Access Compliance Report

Public Rights-of-Way

(Curb Ramps)

Intersection ID: 23662	Main Street: CARMEL_RD	Cross Street: RED_OAK_LN	Location: NE
ADA ID: 48779420006C	Ramp Type: Perp	Initial Pass/Fail: Fail	Overall Compliance: No
Severity Score: 13.75			
Codes/Mitigation Info/Possible Solution		Field Measurements/Component Compliance

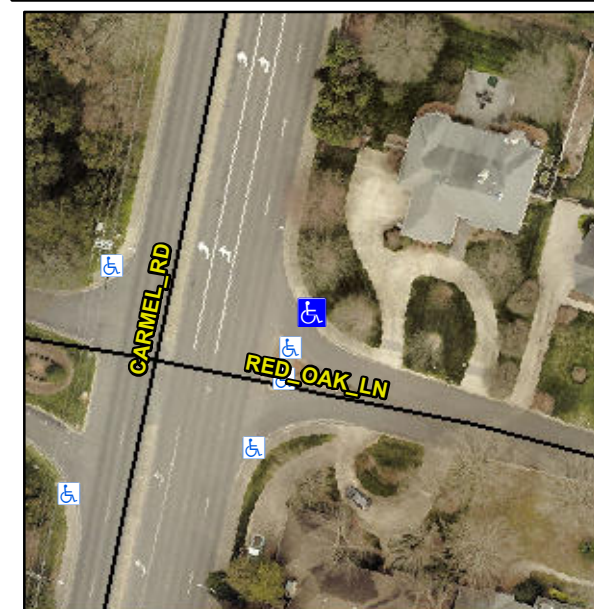
R304.2.2, R304.5.3

Compliance	Description	Data	Compliance	Description	Data
N/A	Ramp Length (in)	55.0	No	Ramp Slope (%)	8.8
Yes	Ramp Width (in)	52.0	No	Ramp XSlope (%)	3.0
N/A	Flare Type LT	N/A	N/A	Flare Type RT	N/A
N/A	Flare Slope LT (%)	N/A	N/A	Flare Slope RT (%)	N/A
N/A	Flare Traversable LT?	N/A	N/A	Flare Traversable RT?	N/A
N/A	Landing Length (in)	N/A	N/A	DWS Provided?	N/A
N/A	Landing Width (in)	N/A	N/A	DWS Contrast?	N/A
N/A	Landing Slope (%)	N/A	N/A	DWS Length (in)	N/A
N/A	Landing X Slope (%)	N/A	N/A	DWS Full Width?	N/A
N/A	Landing Curb? (Y/N)	N/A	N/A	DWS Offset (in)	N/A
N/A	Shared Landing?	N/A			
N/A	Gutter Ponding?	N/A	N/A	Gutter Slope (%)	N/A
N/A	Gutter Lip Ht (in)	N/A	N/A	Gutter X Slope (%)	N/A
N/A	Painted X Walk1?	No	N/A	Painted X Walk2?	N/A
	X Walk 1 Direction	To SW		X Walk 2 Direction	N/A
N/A	X Walk 1 Width (in)	N/A	N/A	X Walk 2 Width (in)	N/A
	X Walk 1 Slope (%)	0.5		X Walk 2 Slope (%)	N/A
	X Walk 1 X Slope (%)	5.5		X Walk 2 X Slope (%)	N/A

Remove & Replace Entire Ramp.
